Appeal of Parish Planning Commission Action
Miramar Subdivision Resubdivision of Lots 1-6

Case No. PC2021-0052

RE: MIRAMAR SUBDIVISION RESUBDIVISION OF LOTS 1-6 into 1A-1C, 2A-2D, 3A-3C, 4A-4D, 5-A-5-D & 6A-6E (PC2021-0052) ACTION LETTER

LAFAYETTE PARISH PLANNING COMMISSION STAFF REPORT

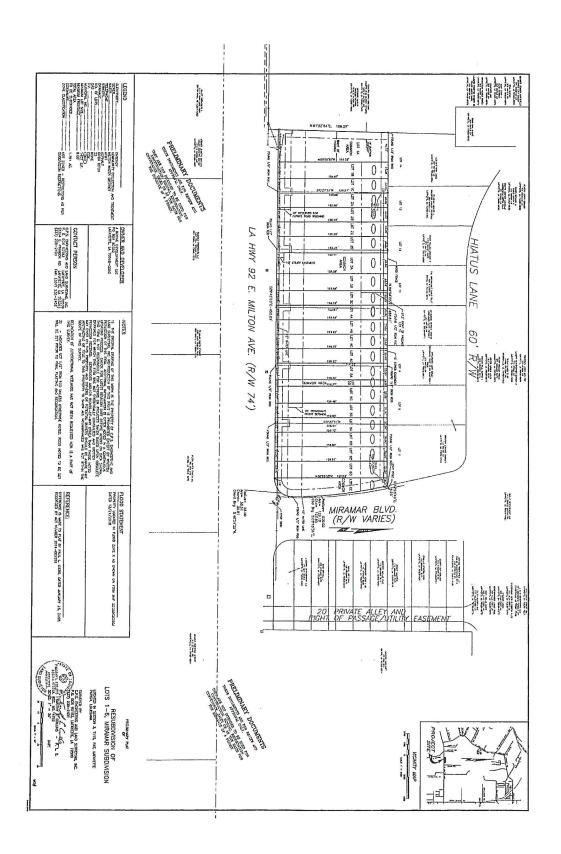
1. Addresses are pending.

- 2. Label the "37.5' Right of Passage as a "Private Street/Utility Easement".
- 3. Indicate in the plat title that this is a residential development.
- 4. If the residences are attached, this must be noted on the final plat.
